INDESIT company

Model type:
LTF11H132OEU

Commercial code:
F082891

Technical Documentation guidelines

2300140 Exploded views

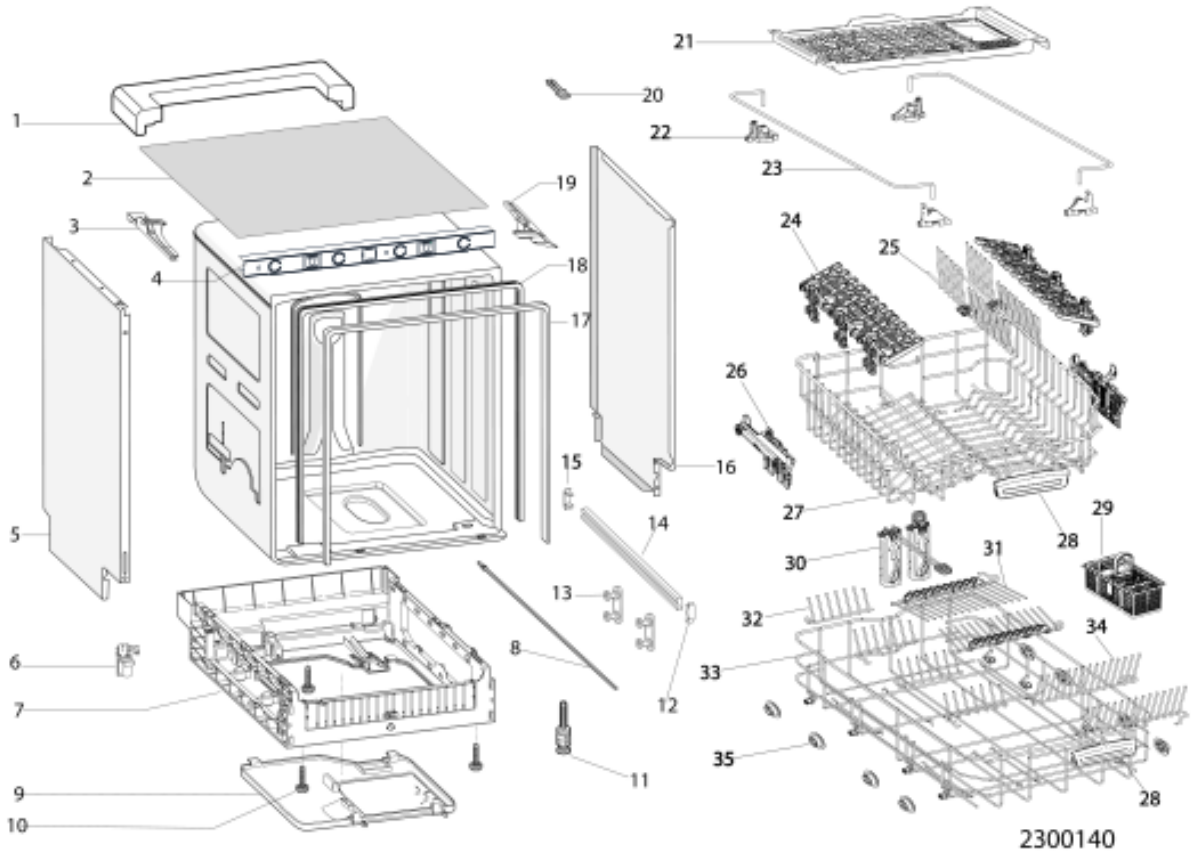
n4514g00: Changed the flaps system

From SN 26.03.2014 the flaps and flap supports will change. Will be 2 longer flaps where was 3 and 4 where was 6.

For products with 3-rd basket changes also:

- 3-rd basket support - will be one code for right and left instead of 2 different codes.

- the code of 3-rd basket wire.

Old and new codes are not interchangeable piece to piece, only as complete set.

2300211 Exploded views

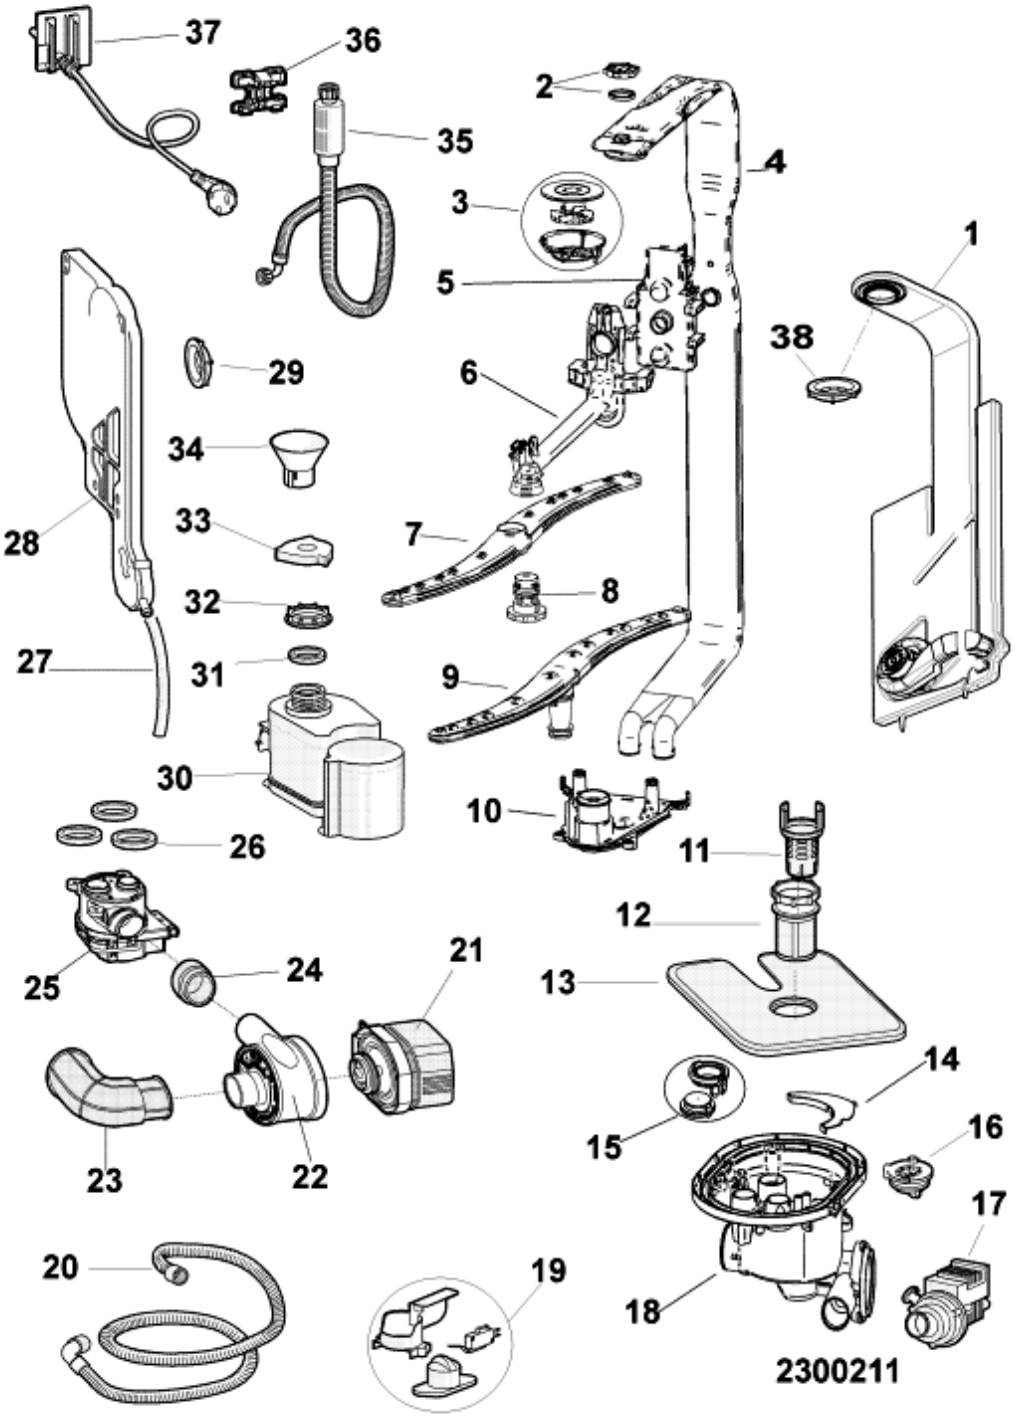
n4513k00: Introduction of new motor and relative file setting

Please check correct serial number

2300340 Exploded views

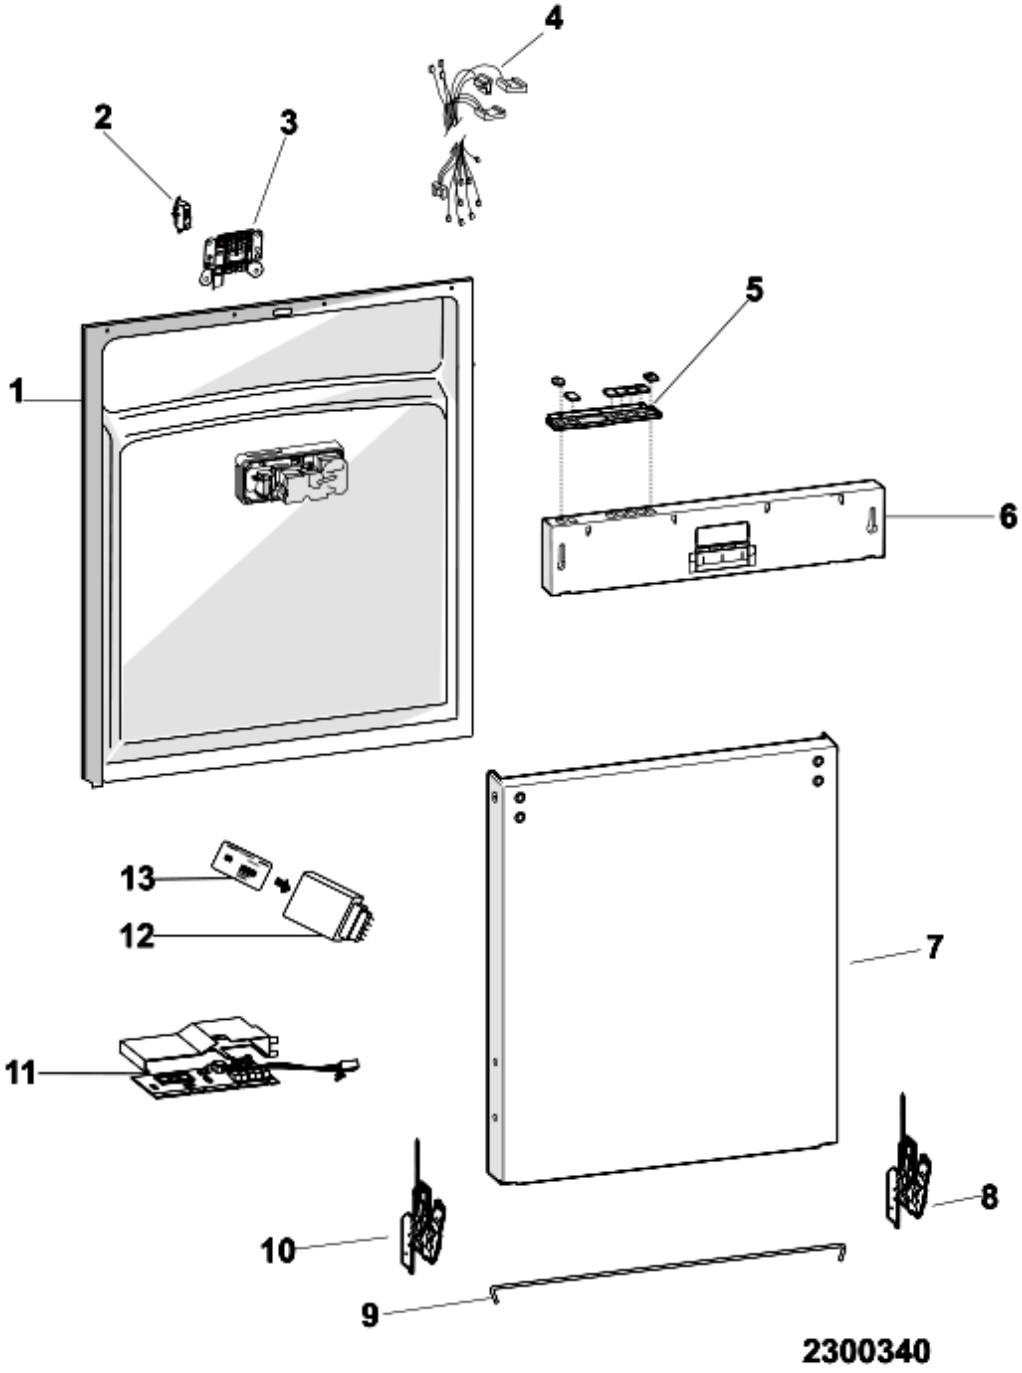
n4513g00: REPLACEMENT INNER DOOR WITH DISPENSER AND OZONE GENERATOR

If you need to replace the inner door, you should order C00298437 but this spare part will arrive without ozone generator.
You must remove the component from the old inner door and mount it on the new one.
The ozone generator is managed as single spare part.

n4514h01: Introduction of new module and relative file setting

Introduction of new module and relative file setting.
Check SN of your product.
